D.O.No. TE-32/5/2024-NDSA-MOWR/11

Reference is invited to 8141/projects-IV/A1/2021 dated 25.04.2024 vide which I&CAD Department has requested to recommend interim measures to be taken up in respect of Medigadda, Annaram, and Sundilla Barrages of Kaleshwaram Project before onset of coming monsoon to prevent further damage to the barrages.

RECOMMENDATIONS ON THE INTERIM MEASURES AND FURTHER STUDIES/INVESTIGATIONS TO BE TAKEN UP BY IRRIGATION & CAD DEPARTMENT, BEFORE THE ONSET OF COMING MONSOON

Fig.-2 Measured levels after the sinking of raft of Block No. -7

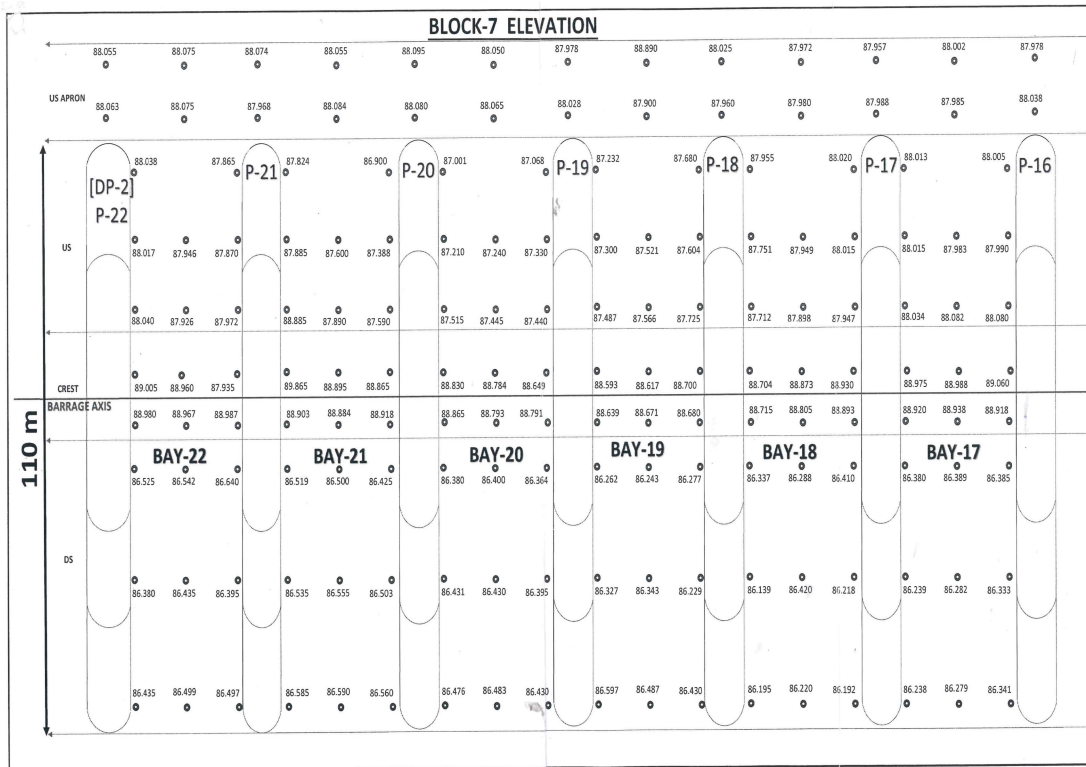
Block No. 7 of the barrage comprises of Pier nos. 11 to 22. The Pier nos. 16 to 21 have undergone settlement to varying depths, and tilting to varying degrees. Cracks have developed in these piers and raft floor of Block-7. The settlement of the piers along with the raft is decreasing from upstream end to downstream in all the piers. The Pier no 20 at its upstream end along with the raft has settled by over 1.2 m. Wide structural crack has developed in pier 20, visibly ranging from a width of around 70 mm near gate crest to around 300 mm at the pier top, extending from the junction of pier and raft to the top of pier, traversing along the upstream periphery of the guide rail of the radial gate at Pier no 20. The reinforcements along the crack for full height of pier have failed. Cracks have developed in the piers on the downstream of the radial gate as well. Structural cracks are also noticed in the adjacent piers. Gantry girder and gantry rail alignment is distorted in horizontal direction in few of the piers. Welding joints between the two gantry girders over pier are distorted. The measured levels after sinking of raft and upstream plinth slab of block no.-7 is shown at Fig.-2, which points to the fact that the magnitude of the settlement failure in Block No -7 is quite extensive.

1. The following activities/measures shall be carried out in the given sequence below for Block No.-7:
 - a. Crack monitoring at appropriate locations shall be carried out to an accuracy of +/- 1.0 mm, through appropriate techniques such as tell-tales etc., for continuous monitoring of the movement across all the cracks in piers and raft floor.

- b. Pier nos. 16 to 22 have either tilted or have developed cracks to varying magnitude. These piers shall be adequately braced at appropriate locations with suitable bracing system. Lattice girder/truss or box girder can also be used to arrest any likely lateral movement. While doing so, adequate precautions shall be taken that no heavy loads are transferred on to the raft.

- c. Defective or damaged Pressure Release Valves in the raft shall be rectified or replaced.
 - d. Optical targets shall be installed on top level of all piers of Block No-7, one each at the upstream end, at the downstream end and at the middle, which shall be continuously monitored through a Total Station, and record maintained.
